## ***Proposed District Plan Change 60***

**Churton Park Suburban Centre Rezoning**

August 2007

# Proposed District Plan Change

## **Appendix 8 Churton Park Village Concept Plan**

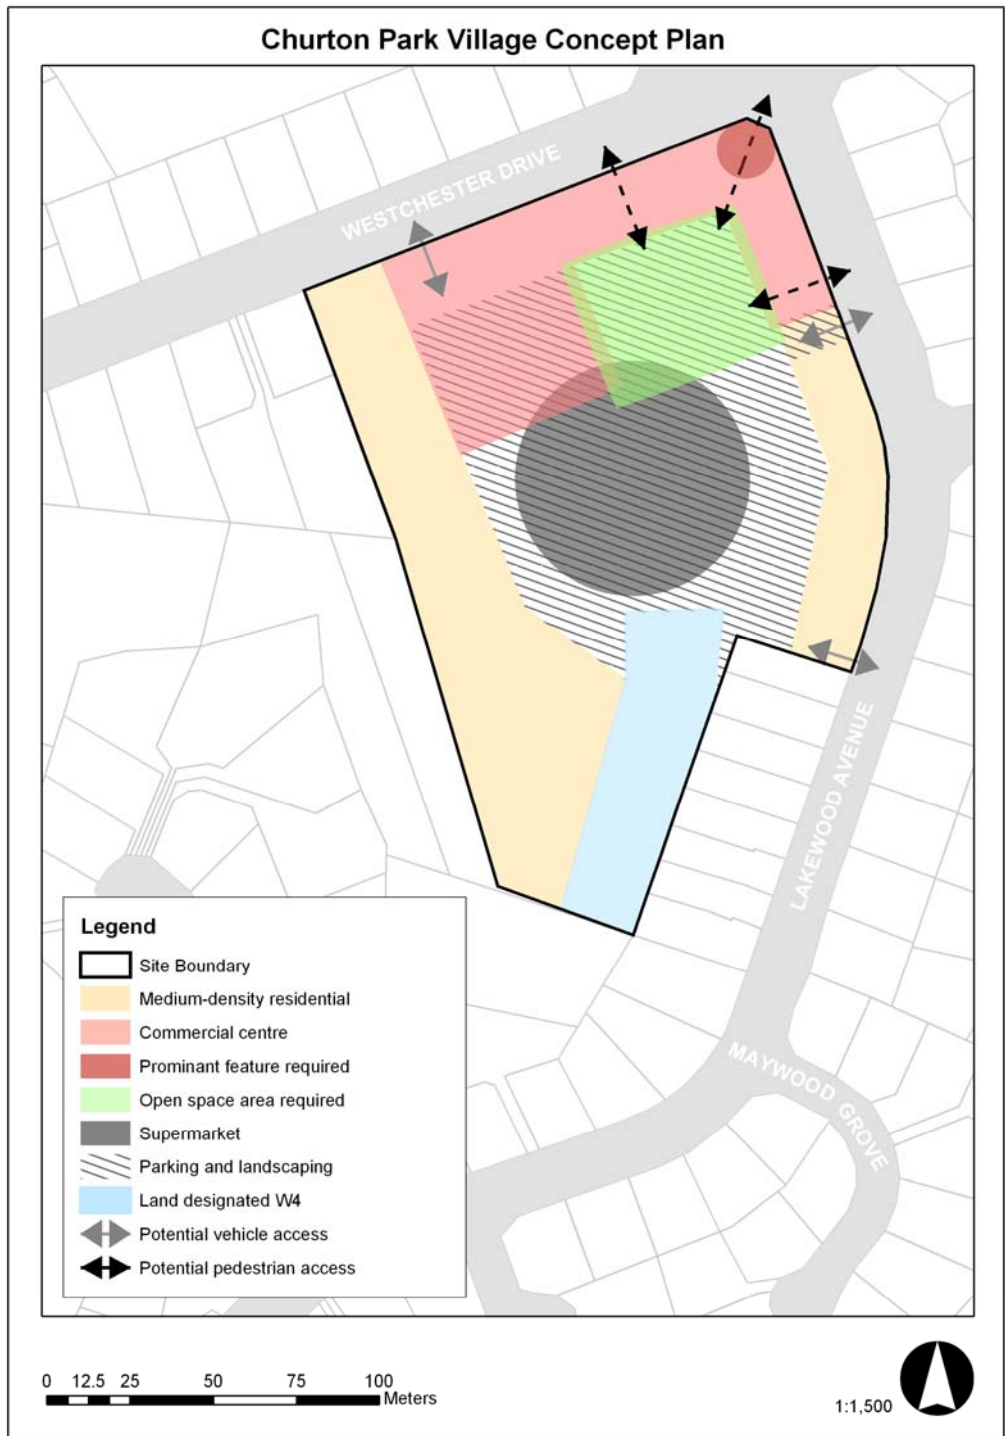
The different activity areas shown on the map do not represent the absolute location, footprint or specific land area to be used. Rather, these are diagrammatic representations of the general locations for buildings and activities. There is no specific requirement to either develop adjoined or separate buildings in any on part of the village. The final size, location and design of any component of the village required by the Concept Plan and shown on the map will be assessed through the resource consent process. Any subdivision will also be assessed through the resource consent process for compliance with the requirements and compatibility with the map of the Concept Plan. Additionally, given that timing of development or subdivision of any part of the village is uncertain, the Concept Plan anticipates any balance areas not being developed, but remaining in grass cover or be landscape planted awaiting development. In particular, the plan does not intend that undeveloped areas be temporarily developed or used for car parking.

1. A **supermarket** shall be located in the centre of the village with frontages facing towards Westchester Drive and Lakewood Ave. The supermarket shall be serviced from the rear (southern side) with service vehicles using the Westchester Drive vehicle access.
2. The Commercial Centre may only contain **retail, community, commercial, healthcare and related or similar activities**, and residential activities above the ground floor.

3. Buildings comprising the Commercial Centre component of the village shall **occupy and engage the public street edge** along Westchester Drive and Lakewood Ave.

4. The Commercial Centre buildings must incorporate **display windows and verandah cover**, as identified on planning map 47.
5. A **prominent landmark corner feature** using prominent building form supported by signage, landscaping or a combination thereof must be included on the street corner as shown on the map.

6. A dedicated **open space area**, free from vehicles and car parking, must be created adjacent to the commercial activities and be provided with visual and physical connections to the public street. The exact number and locations of these connections will ultimately depend on building design and layout. The connections shown on the map are indicative.

7. **Medium density residential housing** shall flank the western boundary of the zone and front a portion of Lakewood Ave between the commercial activities and the southern boundary of zone.

Appendix 1 - Rezoning of Residential land on Lot 3 DP 311793, Churton Park

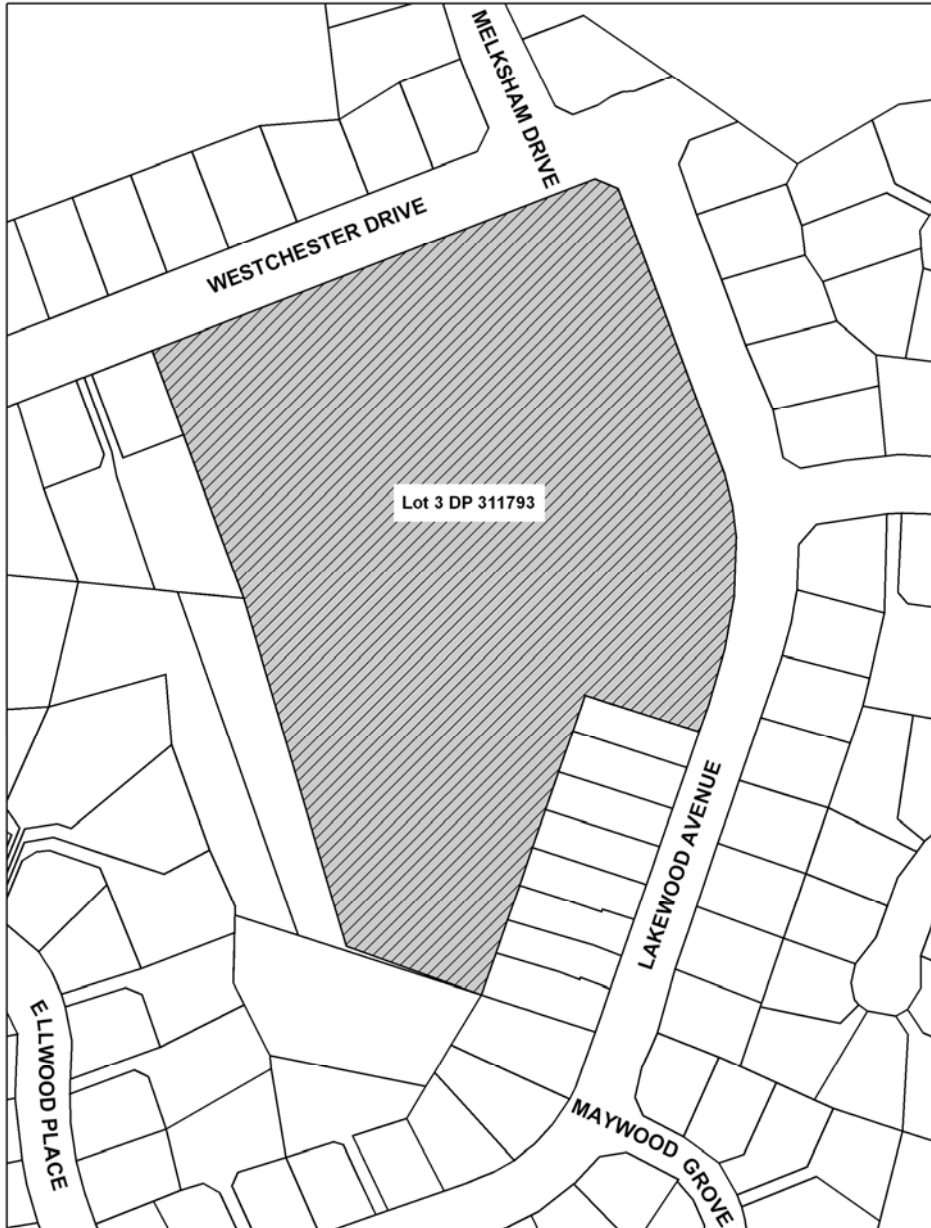
**9.0 Amend planning map 26** by colouring the site on the south west corner of Westchester Drive and Lakewood Avenue for Suburban Centres zone.

Land currently zoned Outer Residential to be zoned Suburban Centre
